Access Compliance Report Public Rights-of-Way (Curb Ramps)

Main Street: COVENTRY_PL Cross Street: BRADCLIFF_DR Location: N

ADA ID: RPRK211013110252 Ramp Type: Type 4 - Parallel Initial Pass/Fail: Fail Overall Compliance: No Severity Score: 30

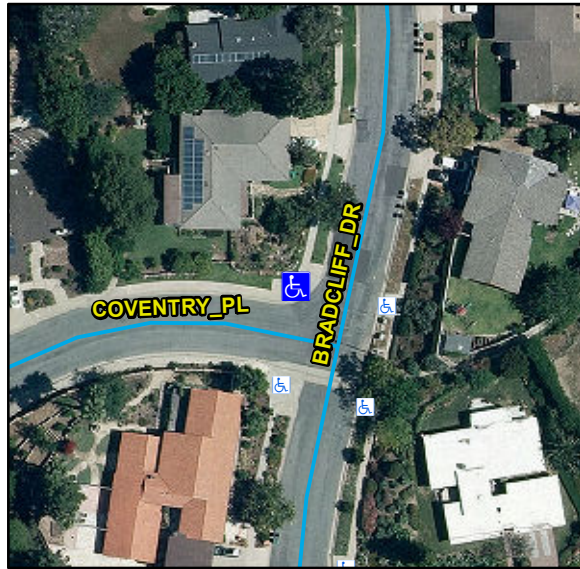
Compliance	Description	Data	Compliance	Description	Data
N/A	Ramp Length LT (in)	124	N/A	Ramp Length RT (in)	130
Yes	Ramp Width LT (in)	142	Yes	Ramp Width RT (in)	136
Yes	Ramp Run Slope LT (%)	5.2	No	Ramp Run Slope RT (%)	11
No	Ramp Cross Slope LT (%)	5.2	No	Ramp Cross Slope RT (%)	3.4
N/A	Landing Present	N/A	N/A	DWS Provided	N/A
N/A	Landing Length (in)	N/A	N/A	DWS Contrast	N/A
N/A	Landing Width (in)	N/A	N/A	DWS Length (in)	N/A
N/A	Landing Run Slope (%)	N/A	N/A	DWS Full Width	N/A
N/A	Landing Cross Slope (%)	N/A		DWS Offset Type	N/A
N/A	Landing Movement Obstructed?	N/A	N/A	DWS Offset Left (in)	N/A
	Landing Movement Type	N/A	N/A	DWS Offset Right (in)	N/A
N/A	Landing Shared	N/A			
N/A	Clear Space	Yes			
N/A	Clear Space To Crosswalk (in)	N/A			
N/A	Marked Crosswalk 1	No	N/A	Marked Crosswalk 2	No
	Crossing 1 Direction	SW		Crossing 2 Direction	SE
	Marked Crosswalk 1 Width (in)	N/A		Marked Crosswalk 2 Width (in)	N/A

Remove & Replace Curb Ramp With Two New Directional Ramps or Equivalent.
